**1.0 APPLICATION SUMMARY**

Applicant: GHS MLK 11, LLC

APPLICATION NUMBER: PRS 25-1377

AGENCY REVIEW COMMENT SHEET

2.4 Proposed Site Plan (partial provided below for size and orientation purposes. See Section 8.2 for full site plan)

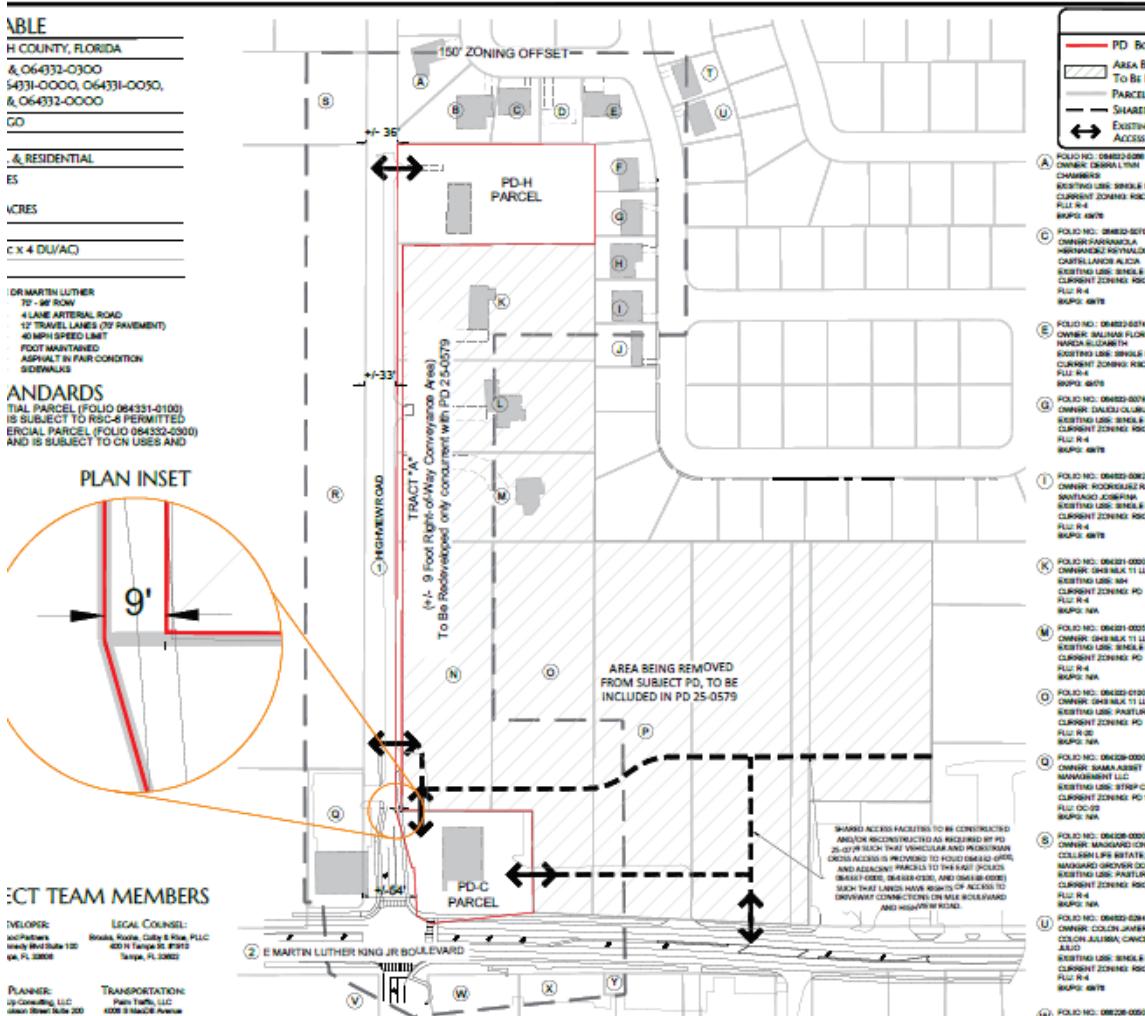
The modification will result in two remaining parcels in PD 90-0012 (Folios: 064332-0300 and 064331-0100), connected via a nine-foot tract of land (Tract "A") comprised of the remaining portions of the following parcels: 064331-0000, 064331-0050, 064331-0025, and 064332-0000. The remaining PD 90-0012 portion in the southwest will allow commercial uses, as is proposed under PD 25-0579 adjacent to east of the site. The remaining portion in the north will continue to allow residential. PD 25-0579 addresses compatibility with the existing residential to the north and east, which staff determined to be compatible.

Approval - Approval of the request, subject to the conditions listed below, is based on the general site plan submitted January 2, 2026.
